Application for Variation of an Environmental Permit

C1. Name of the Current Environmental Permit Holder :
Civil Engineering and Development Department
C2. Application No. of the Current Environmental Permit : VEP-607/2021 (EP-210/2005/E)
C3. The Current Environmental Permit was Issued in : month / year
1 | 2 | 2 | 0 | 2 | 1

Environmental Review for Extension of Operation of Fill Bank at Tuen Mun Area 38 (2024-2028)

VEP Supporting Document

Figure 2.2
圖 2.2

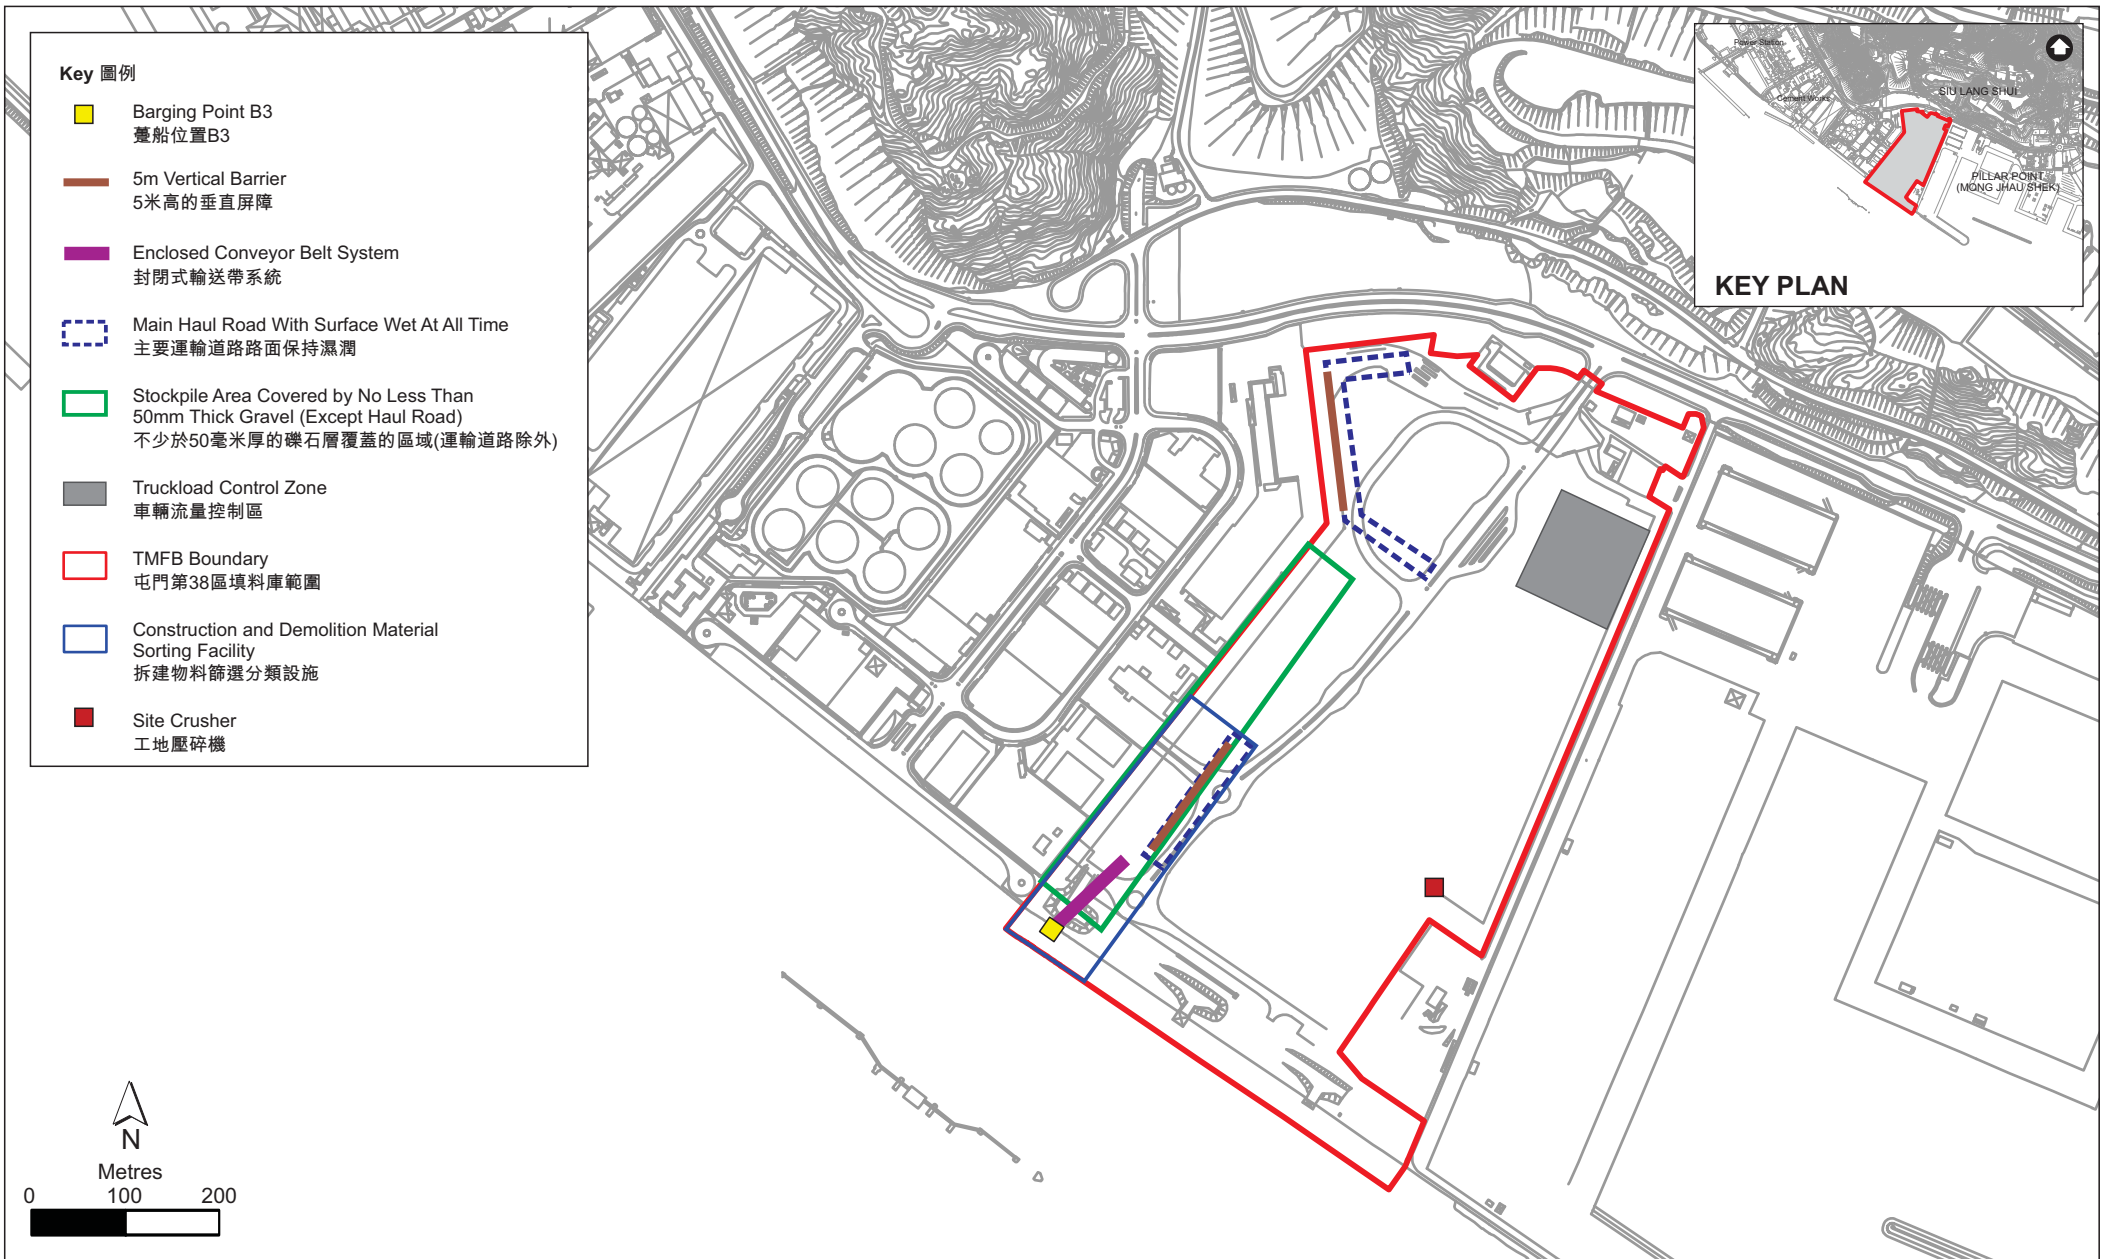
The maximum stockpiling height is proposed to increase from +40mPD to +65.2mPD. Hence, it is proposed to vary Condition 3.2 of the current EP (i.e. EP-210/2005/E) as follows:

*“The maximum stockpiling height at the fill bank shall be limited to a maximum of ~~+40mPD~~ **+65.2mPD**. From 1 January 2014, ~~a~~ **a** minimum of 3.2 hectares of stockpile area shall be covered with no less than 50mm thick gravel at the designated location (as indicated in Figure 2).”*
